# INSPECTION NOTICE

## PROTECTA REBEL SRL

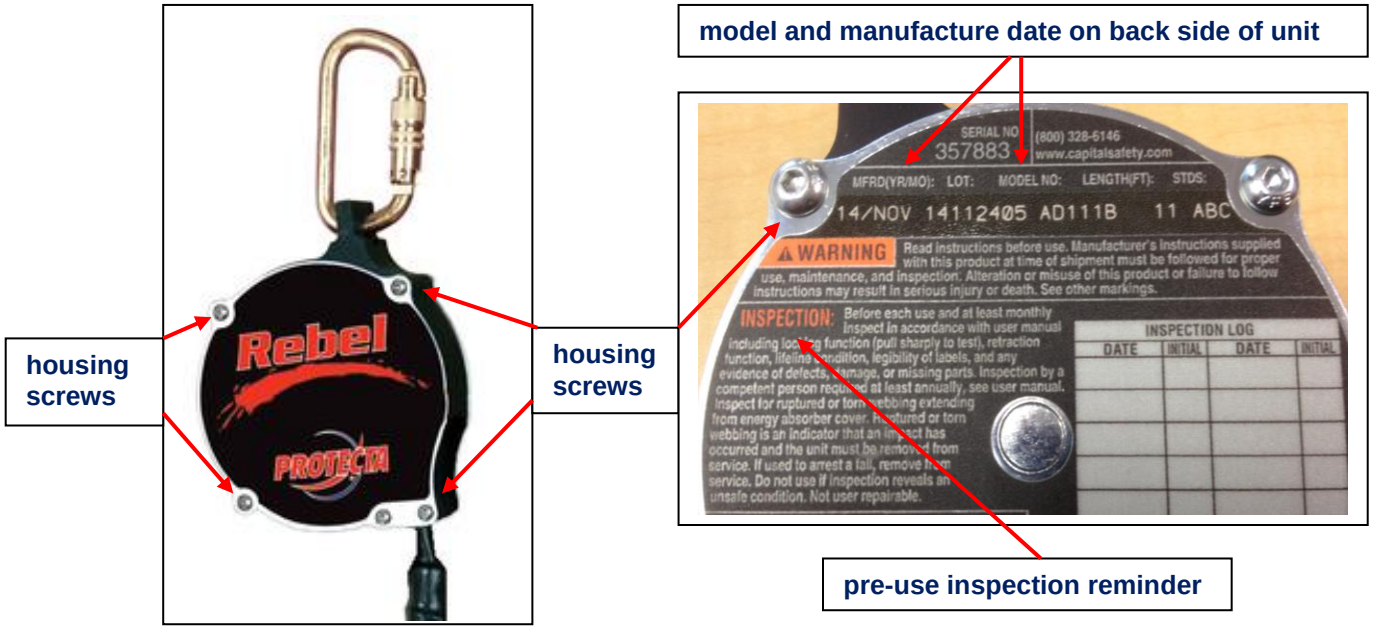
Capital Safety has learned of broken screw heads found in a limited number of Protecta brand Rebel Self-Retracting Lifelines (SRLs). The units affected by this notice are the black, extruded aluminum housing versions of the Rebel, manufactured between 1 April 2014 and 30 November 2014. (See photograph below.) The affected models are:

Although these units passed final assembly inspection by Capital Safety, reports indicate that the heads of some housing screws have been found broken off by end-users. These units have a total of ten externally visible screws that attach the two exterior housing plates to the main housing (five screws on each side, front and back).

a) remind your workers to conduct pre-use inspections of their Rebel SRLs (as well as their other fall protection equipment);
   - the Rebel pre-use inspection checklist is
     i. summarized on the product label under “Inspection” (see photograph on previous page), “check for any evidence of missing parts” and
     ii. set out in full in the Rebel user manual, including the specific requirement to check that “all screws and rivets are present.”
   - missing or broken housing screw heads will be readily visible;

Only the Protecta Rebel SRL models identified above are affected by this notice, and only those units manufactured between 1 April 2014 and 30 November 2014. Although we are confident this issue is limited to a select manufacturing lot of screws supplied by our vendor, we have taken the precaution of changing the type of screws used in these units to eliminate any potential of the condition reported.

b) if any housing screw heads are missing or broken, take the unit out of service;
c) if no housing screw heads are missing or broken, the units are safe to remain in service.
